18 April 2023

Central Hobart Precinct Plan consultation

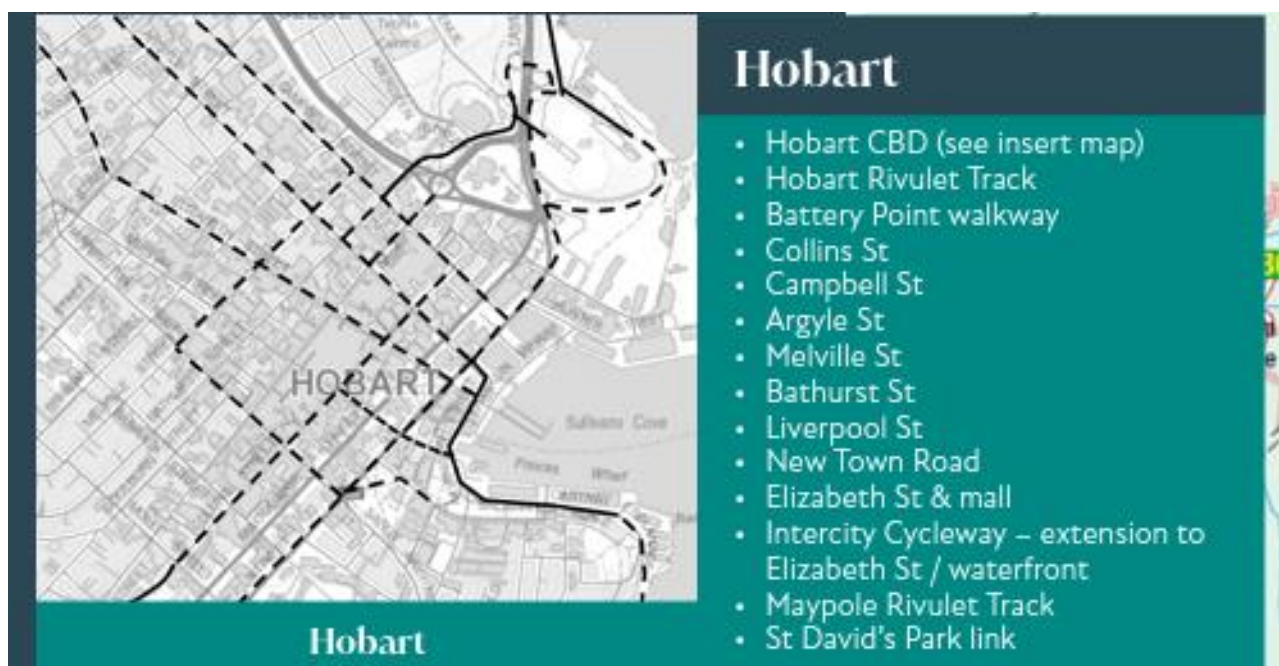
- Cyclists should not be placed in the dooring zone of parked cars. This means that the cross section provided for Elizabeth St on page 126, for example, should be flipped so that parked cars are next to the uphill separated lane buffer and the people riding downhill in the traffic lane don't also have to contend with parked cars on their left. So a better cross section for the Elizabeth St example would be:

- Low-speed shared zones that don't have low traffic volumes should be avoided so we don't have the situation where people riding are stuck in long lines of traffic with no way out. It's also an intimidating environment for the majority of people who want to ride if there are a lot of vehicles, even if speeds are low. These sorts of treatments work better if the traffic volumes are very low or limited to public transport and delivery vehicles.
- Cycling should be a quick, direct way of moving through the city to encourage people to choose it as a travel option. Shared zones should still allocate space for people riding and scooting to give greater certainty for all users, whether that's through use of signage, surface treatments or colour. An example of this is in Lennox Street in Richmond in Victoria a 10 km speed limit and contraflow lane for bicycles:
